<p>Safety Recall: NHTSA # 26V-233 April 2026</p>
--

IMPORTANT SAFETY RECALL

Jayco Inc. has decided that certain Model Year 2025-2026 Entegra Ethos Class B motorhomes fail to conform to the requirements of Federal Motor Vehicle Safety Standard number 110, "Tire Selection and Rims."

Occupant and Cargo Carrying Capacity Label

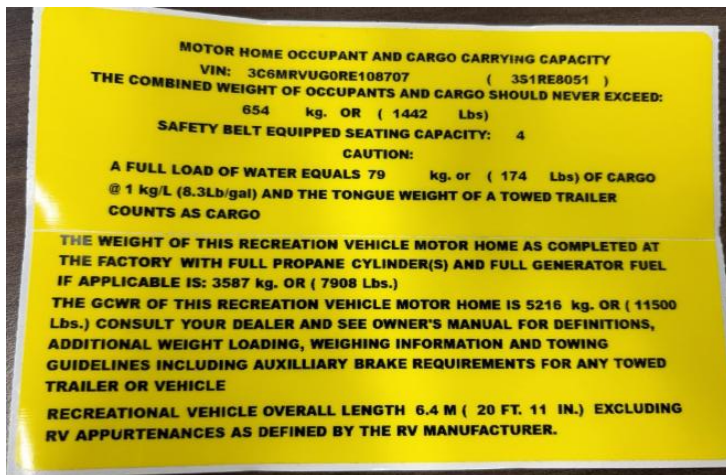
The Occupant and Cargo Carrying Capacity (OCCC) and Tire Loading Information labels state an incorrect number of seat belt equipped seating positions, which can result in unbelted passengers. Unbelted passengers may not be properly restrained in a crash, increasing their risk of injury.

Remove existing label

1. There are two locations for the Occupant and Cargo Carrying Capacity Labels. One label will be affixed on the Driver side door B' pillar and the other label will be affixed inside of the passenger door. The Tire and Loading Information label will be affixed on the Driver side door B' pillar
2. Remove the existing labels. Using isopropyl alcohol and a shop rag, remove any adhesive residue from the surface where the original labels were removed.
 - a. Allow the area to dry for at least 30 seconds.

Apply new label

1. Remove the protective back from the new label. Align the new label in the same location as the original label and apply it to the surface. Remove any air bubbles from the label.
 - a. Note: Do not attempt to remove or adjust the label once it has touched the surface. Doing so may damage the labels or cause it not to adhere properly to the surface.
